City of Biddeford
Planning Board
January 20, 2021 6:00 PM Zoom Remote Meeting

Planning Board *New Business* Packet Summary for January 20, 2021

**PLANNING
BOARD REPORT**

**RE: 45 Hill Street
Site Plan Application**

1 SITE PLAN

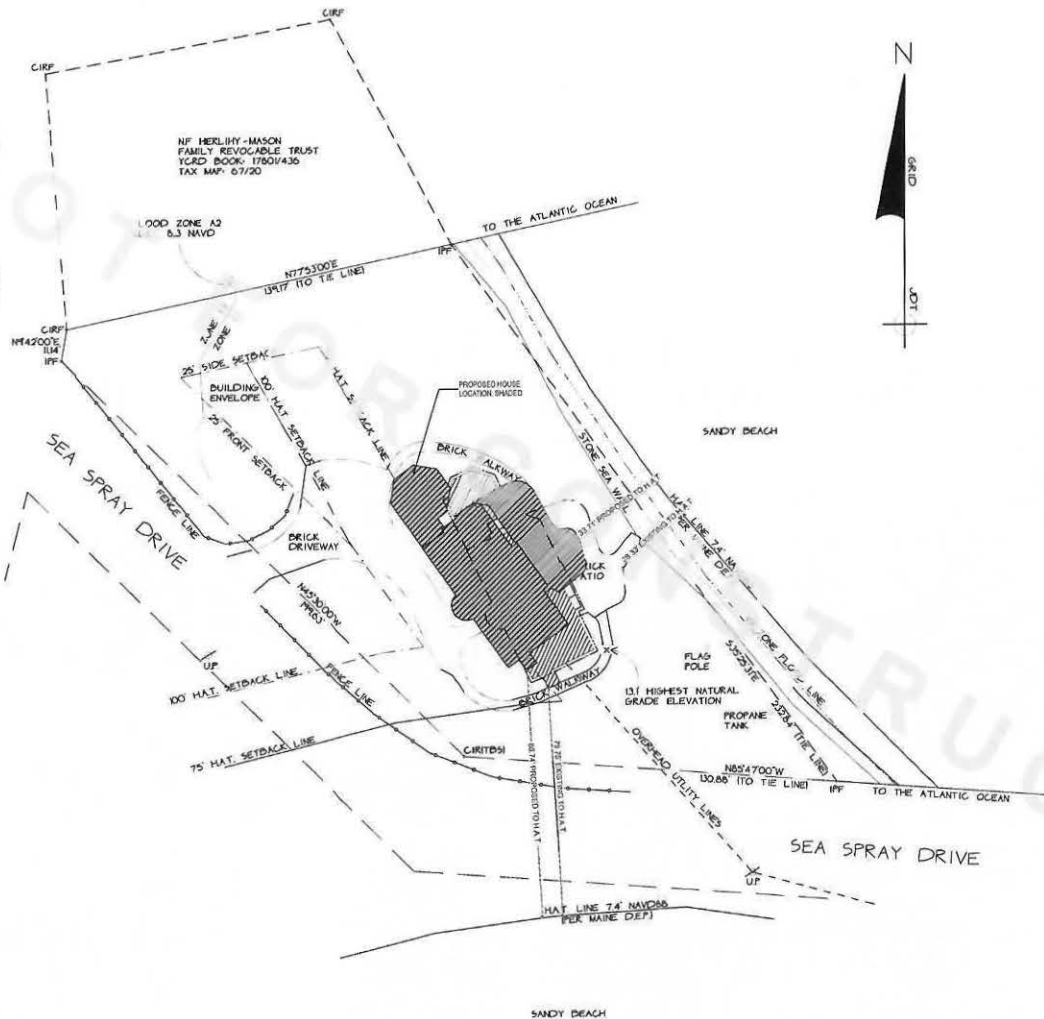
When considering the Site Plan submitted it appears the new location is not as close as possible to the 25-foot Front Yard Setback. Speaking with the applicant's agent, the applicant is concerned with the logistics (i.e. safe and reasonable maneuvering in and out) to relocating the existing driveway further back. The Board should decide if maintaining the driveway location is reasonable

1. The Site Plan needs an approval signatory block, a recording block, and a plan note that describes the regulatory approval that is being sought.

1 SITE PLAN
CS101 SCALE: 1"=10'

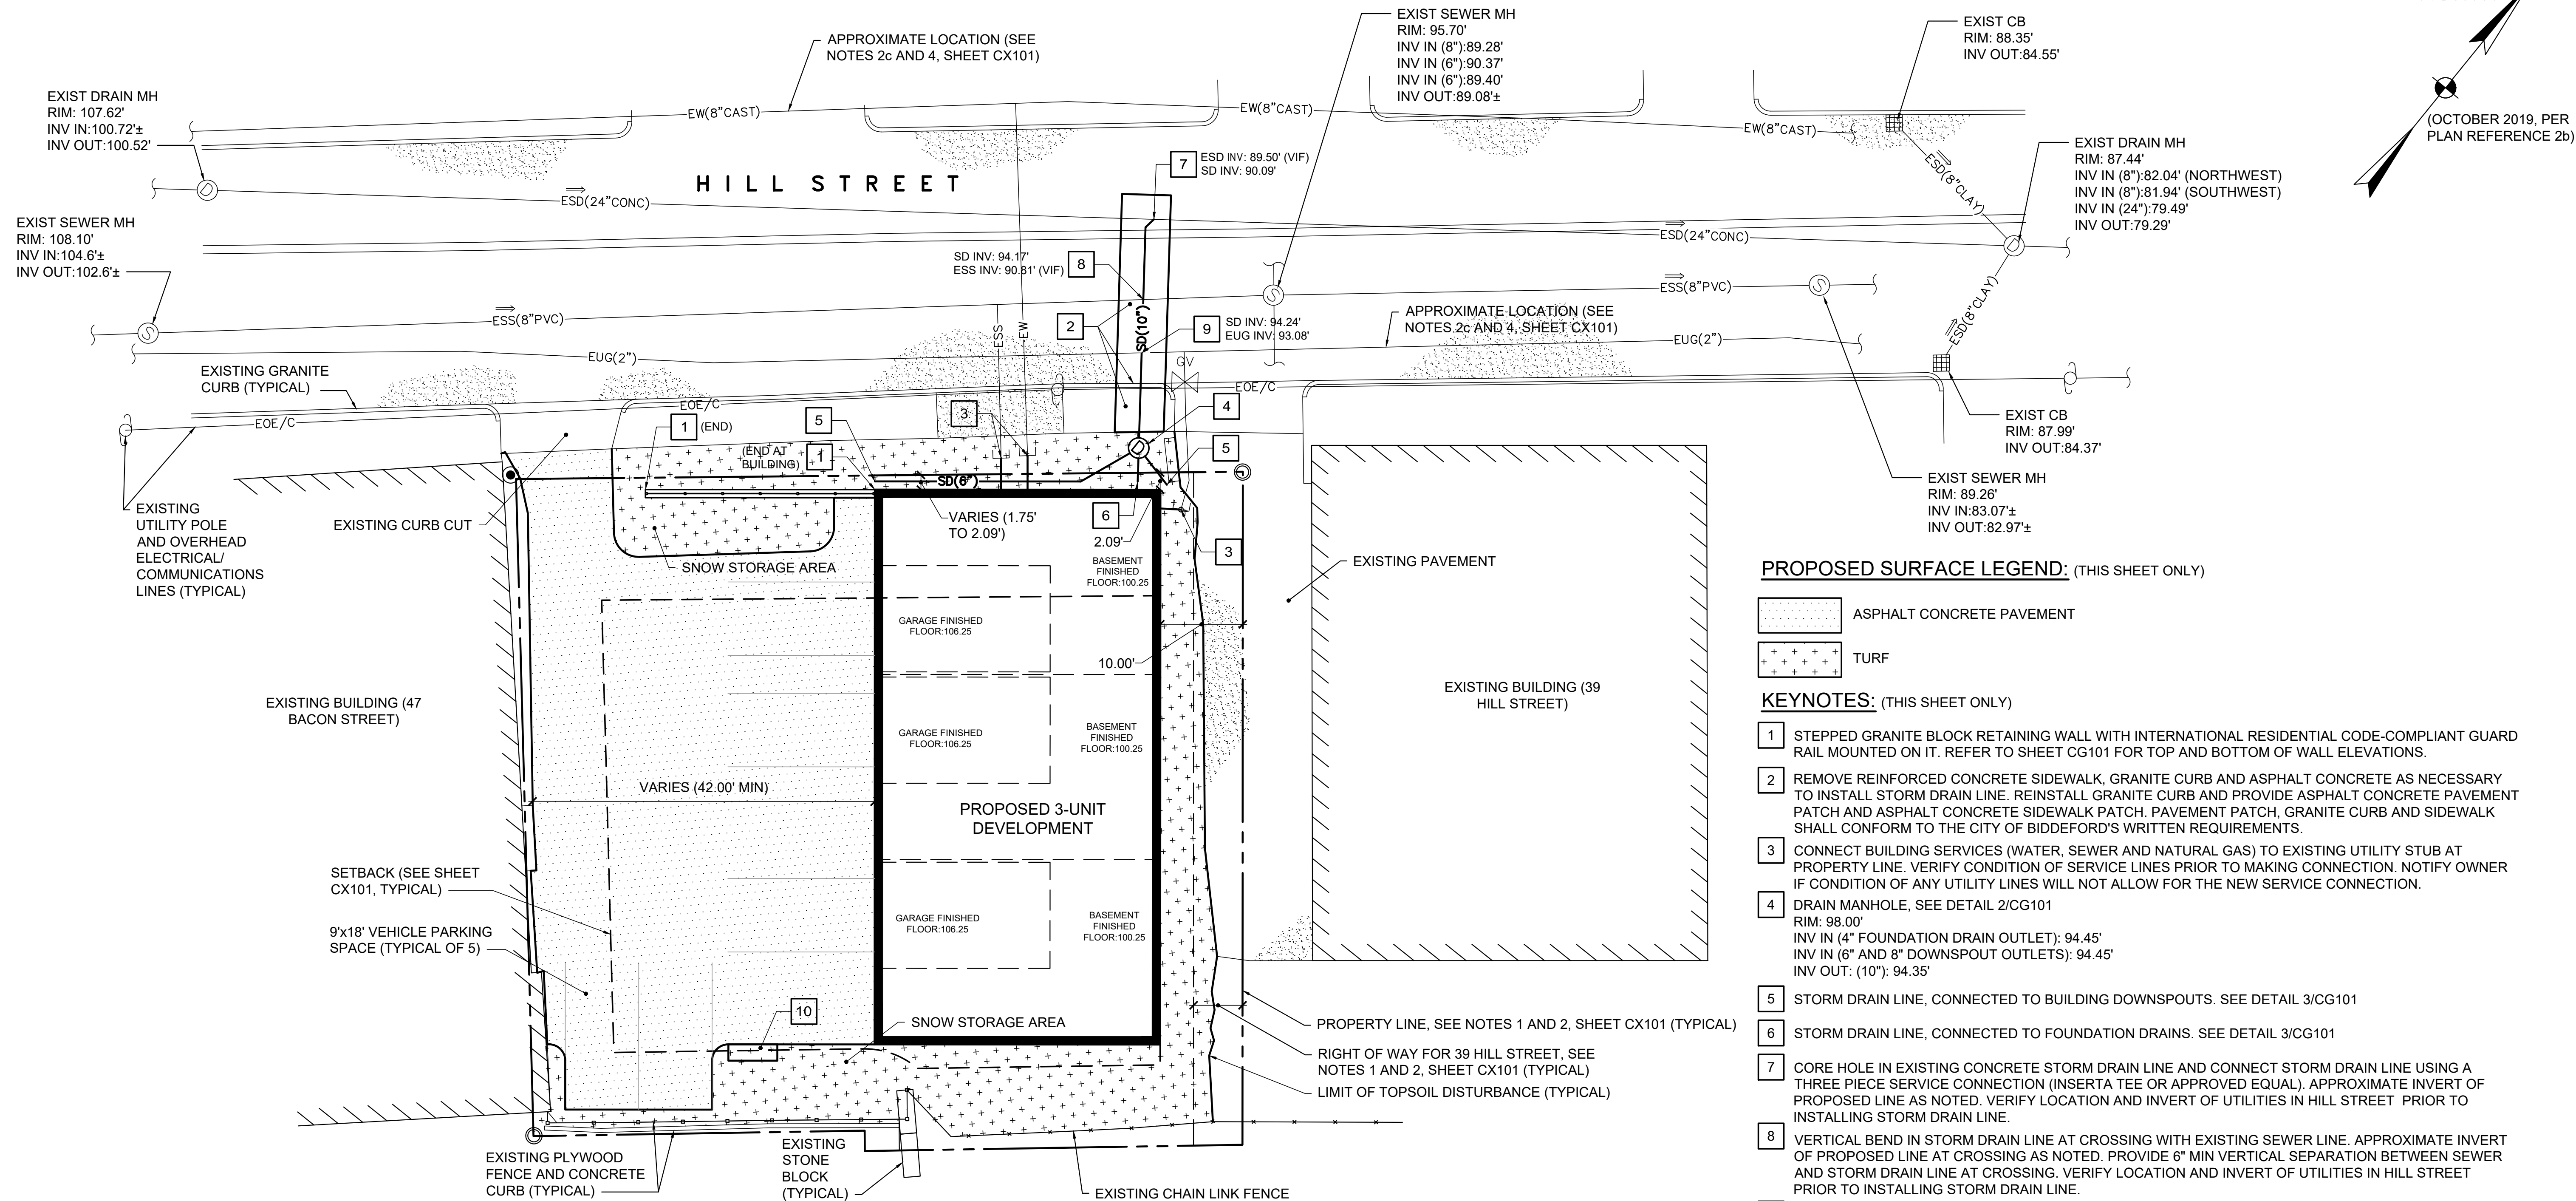
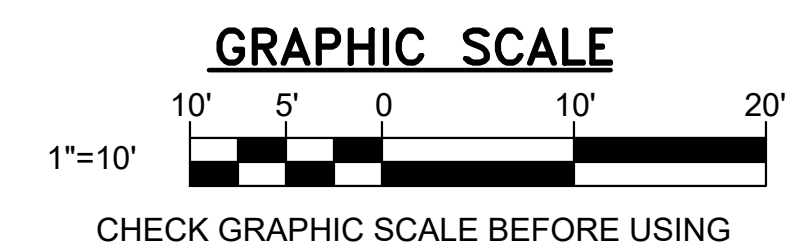
Anticipated parking outside of the proposed garages is not be screened. There is not sufficient space for effective vegetative screening along the southwest portion of the property (adjacent to 47 Beacon Street). Perhaps, if the Board finds this standard pertinent to the application, the Planning Board and the applicant may consider fencing to provide screening in this area and/or at the front of the property. Perhaps in the vicinity of the proposed granite block

Table 6-49B Parking Space Requirements. The minimum required parking for a residential use is 2 spaces per dwelling unit, plus 5% more for multifamily developments. The proposed development complies with providing a total of 8 spaces (3 garaged) where 6.3 is required. The Peer-review Engineer notes the full required width for stall and aisle (18' + 24') is slightly under. This technically requires a waiver, which is reasonable since the existing building to the south appears to encroach on the property. The Final Plan should include the actual parking spaces marked for pavement

1. It should be clearer from the plans that this is a subdivision plan as well as site plan and a recording block needs to be added to the sheets. Perhaps the title is revised to include *Subdivision* along with a plan note that describes the purpose of the plans.
2. The areas for snow storage seem inadequate in size and the applicant should anticipate hauling snow off the property to ensure that the site has appropriate egress and ingress for public safety calls during emergencies. Snow removal should be facilitated by a contract that is funded by the Condo Association and is part of their legal documents.

OPA Response: Landscaping will be limited to turf areas along Hill Street and the northeast and southeast sides of the building as indicated on the Site Plan (sheet CS101).

OPA Response: Parking lot and access drive layout is indicated on the Site Plan (sheet CS101).

OPA Response: Parking lot striping layout is indicated on the Site Plan (sheet CS101).

1 GRADING PLAN

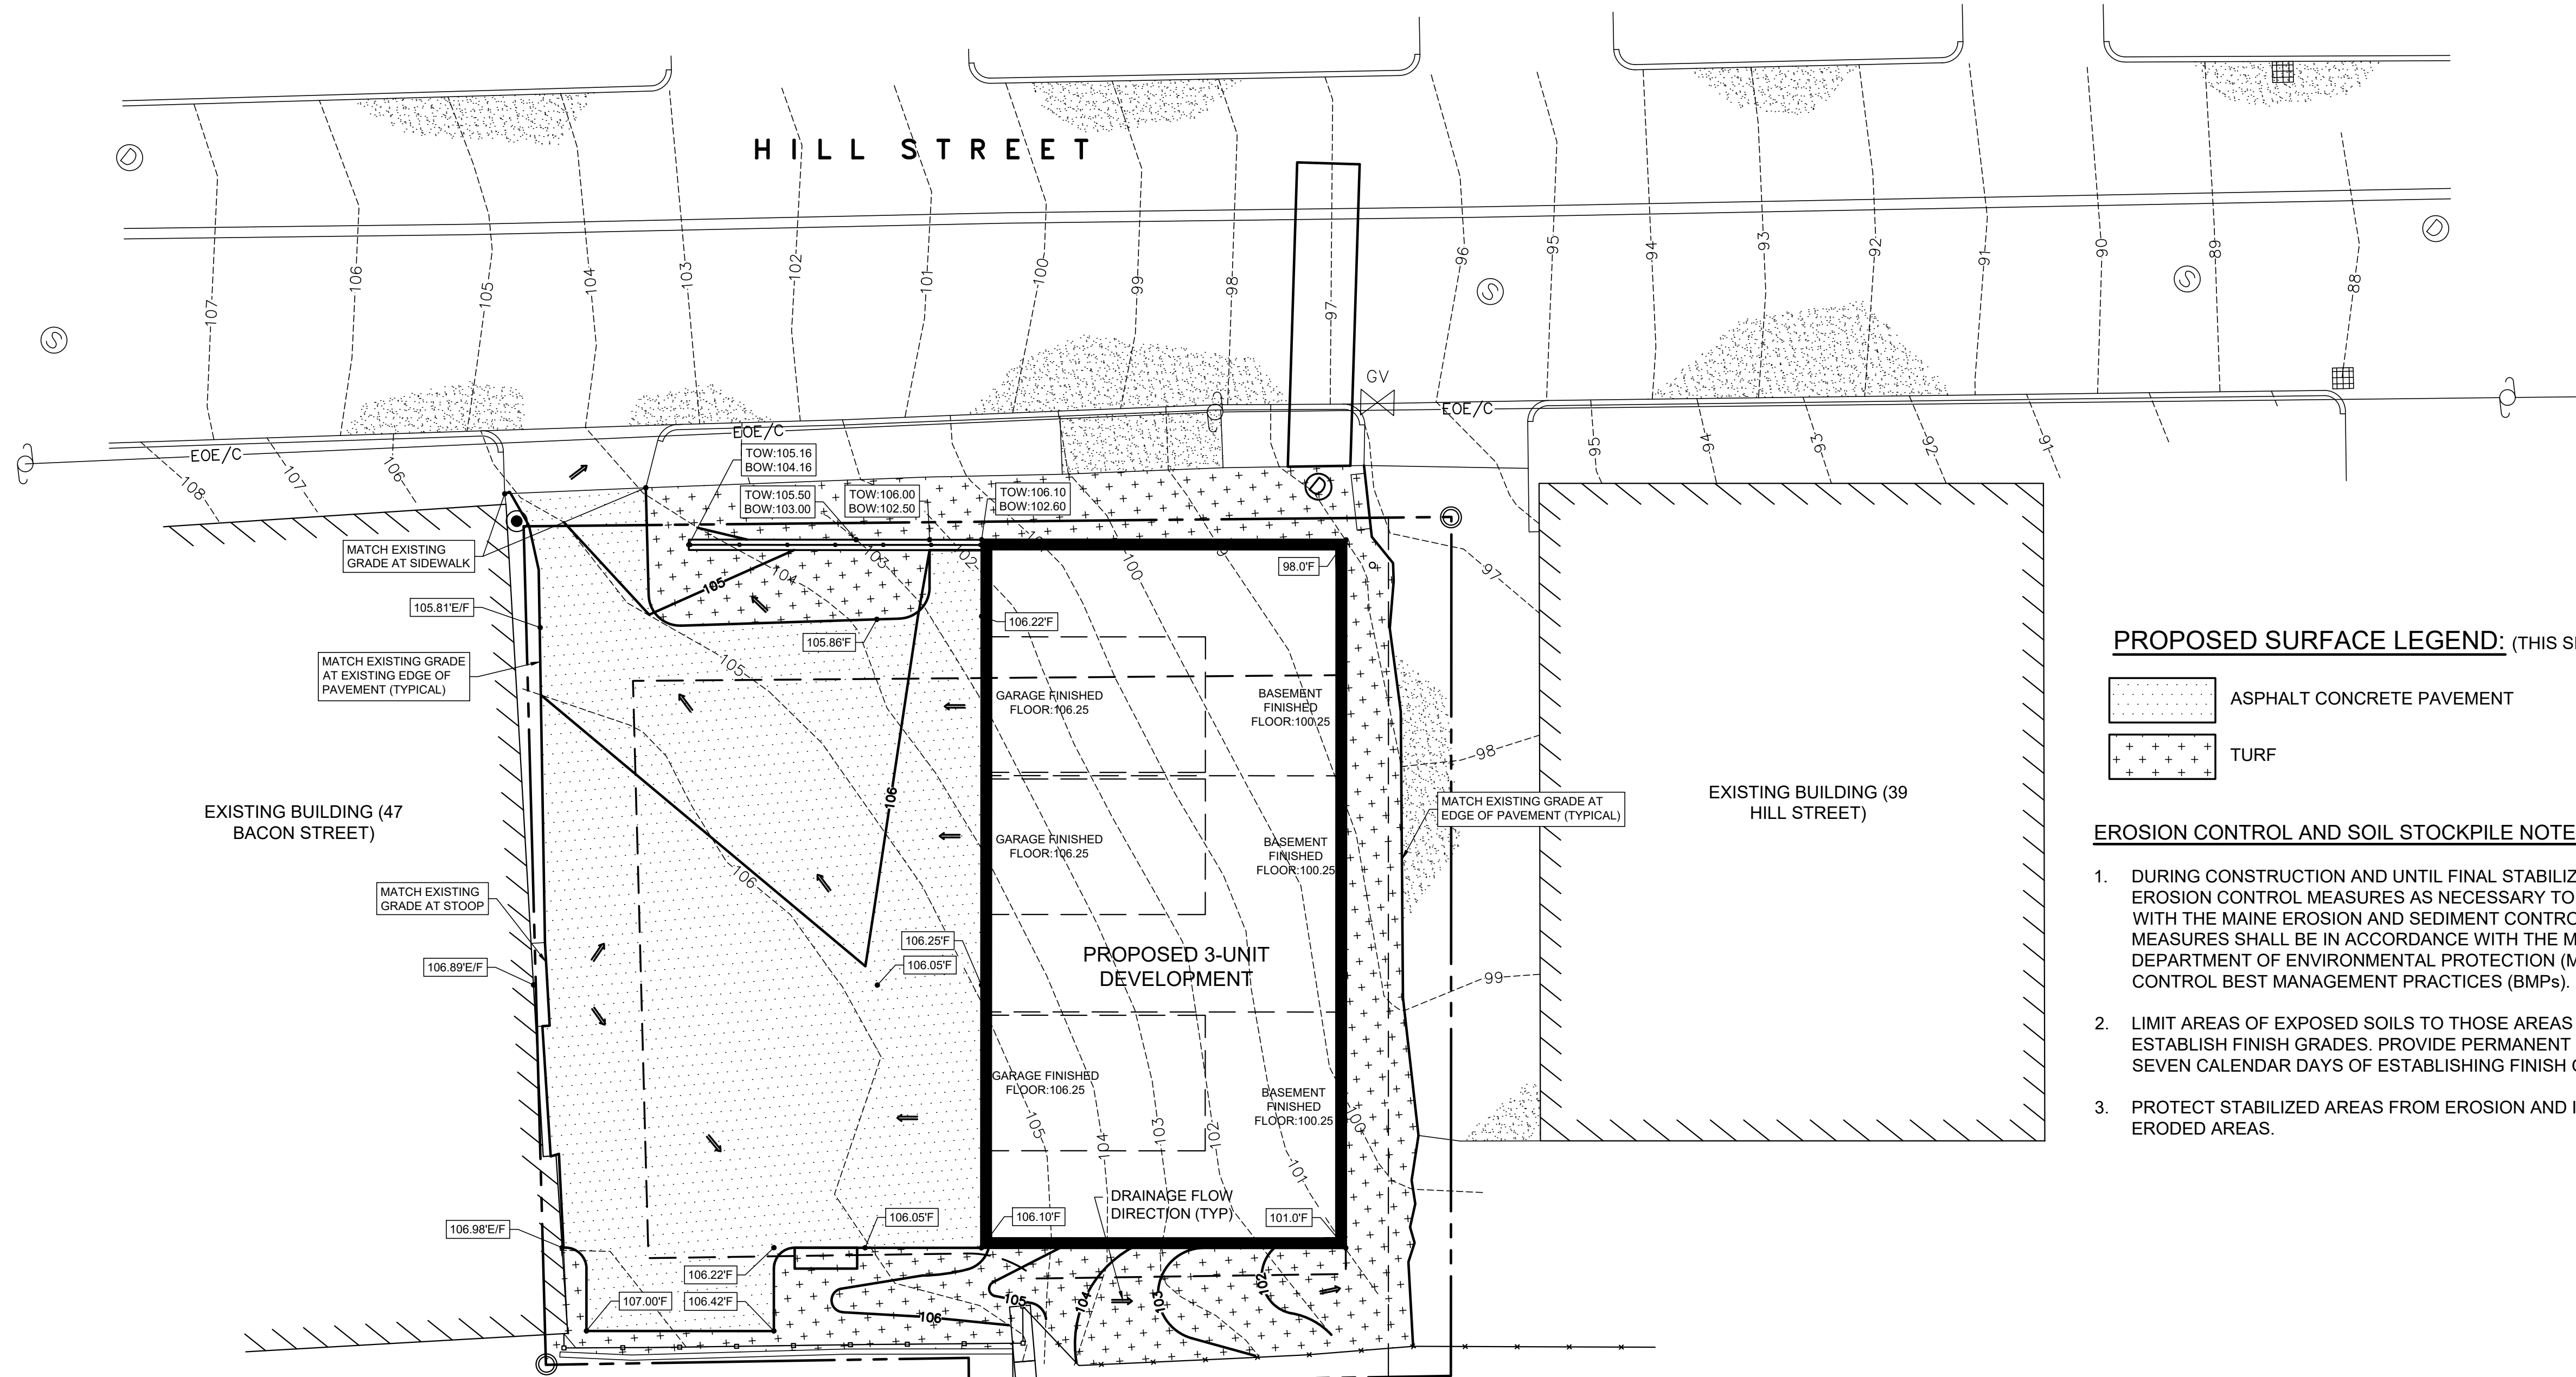
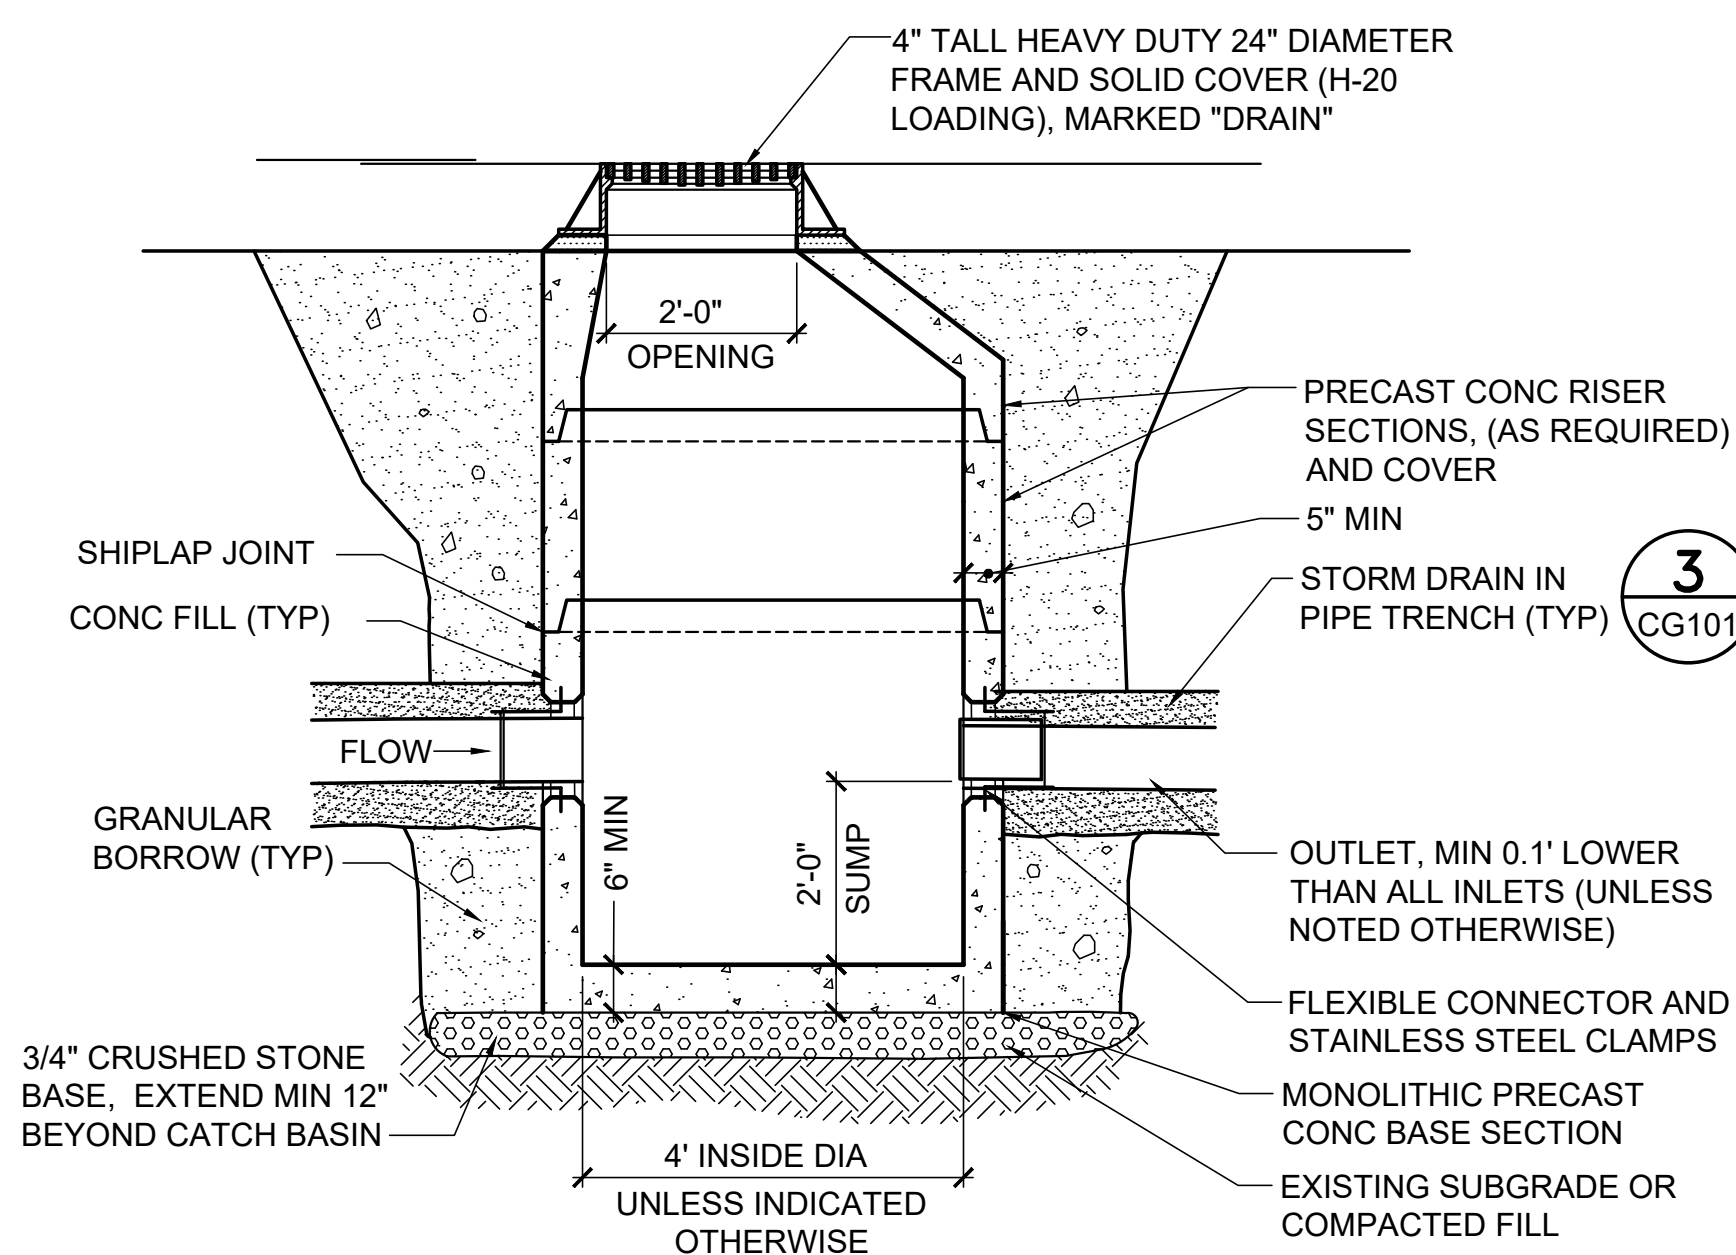
4. Grading Plan – CG101

OPA Response: Site Grading is indicated on the Grading Plan (sheet CG101). This plan also includes erosion and sediment control notes. A stormwater analysis letter is attached.
